Access Compliance Report

Public Rights-of-Way

(Curb Ramps)

Intersection ID: 12110	Main Street: S_MINT_ST	Cross Street: W_4TH_ST	Location: W
ADA ID: 5378A507511F	Ramp Type: Perp	Initial Pass/Fail: Fail	Overall Compliance: No
Severity Score: 22.5			
Codes/Mitigation Info/Possible Solution		Field Measurements/Component Compliance

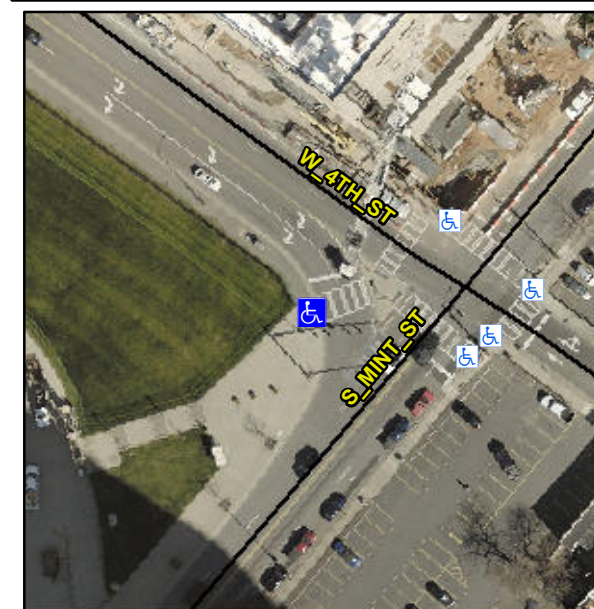
Not Found, R304.5.1, R304.2.2

Compliance	Description	Data	Compliance	Description	Data
N/A	Ramp Length (in)	78.0	No	Ramp Slope (%)	9.0
No	Ramp Width (in)	47.5	Yes	Ramp XSlope (%)	2.8
N/A	Flare Type LT	N/A	N/A	Flare Type RT	N/A
N/A	Flare Slope LT (%)	N/A	N/A	Flare Slope RT (%)	N/A
N/A	Flare Traversable LT?	N/A	N/A	Flare Traversable RT?	N/A
N/A	Landing Length (in)	N/A	N/A	DWS Provided?	N/A
N/A	Landing Width (in)	N/A	N/A	DWS Contrast?	N/A
N/A	Landing Slope (%)	N/A	N/A	DWS Length (in)	N/A
N/A	Landing X Slope (%)	N/A	N/A	DWS Full Width?	N/A
N/A	Landing Curb? (Y/N)	N/A	N/A	DWS Offset (in)	N/A
N/A	Shared Landing?	N/A			
N/A	Gutter Ponding?	N/A	N/A	Gutter Slope (%)	N/A
N/A	Gutter Lip Ht (in)	N/A	N/A	Gutter X Slope (%)	N/A
N/A	Painted X Walk1?	Yes	N/A	Painted X Walk2?	N/A
	X Walk 1 Direction	To E		X Walk 2 Direction	N/A
N/A	X Walk 1 Width (in)	158.0	N/A	X Walk 2 Width (in)	N/A
	X Walk 1 Slope (%)	3.8		X Walk 2 Slope (%)	N/A
	X Walk 1 X Slope (%)	3.2		X Walk 2 X Slope (%)	N/A

Remove & Replace Entire Ramp.
